Integrated Precision Battery Sensor for Automotive System

Silicon Anomaly

ADuC7034

Figure 1. External Power Supply Decoupling Components

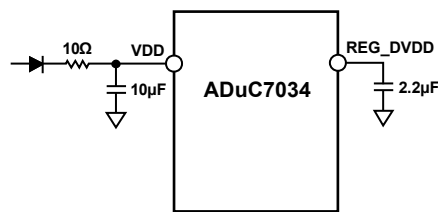
Issue: Under particular conditions, the POR does not release the reset signal, that is, the ASIC remains in reset until a power cycle occurs. This POR issue only occurs under three specific and coincident power-on conditions:

- Fast ramp on VDD, nominally faster than 100 μ s from V_{INIT} to 12 V
- Initial value of VDD (V_{INIT}) = \sim 1.2 V
- Voltage on REG_DVDD at the time VDD ramp is reapplied = \sim 175 mV

Workaround: As previously noted, a fast VDD ramp (that is, ramping from \sim 1.2 V to 12 V in $<$ 100 μ s) is required as one of the conditions to initiate the reported POR issue. Analog Devices recommends careful selection of external power supply decoupling components to ensure that the VDD supply ramp rate can always be guaranteed to be $>$ 100 μ s under all VBAT power-on conditions. Specifically, Analog Devices recommends using a 10 Ω series resistor (1% tolerance maximum) and a 10 μ F decoupling capacitor (20% tolerance maximum) to ground on the VDD line between the reverse protection diode and the VDD, as shown in Figure 1.
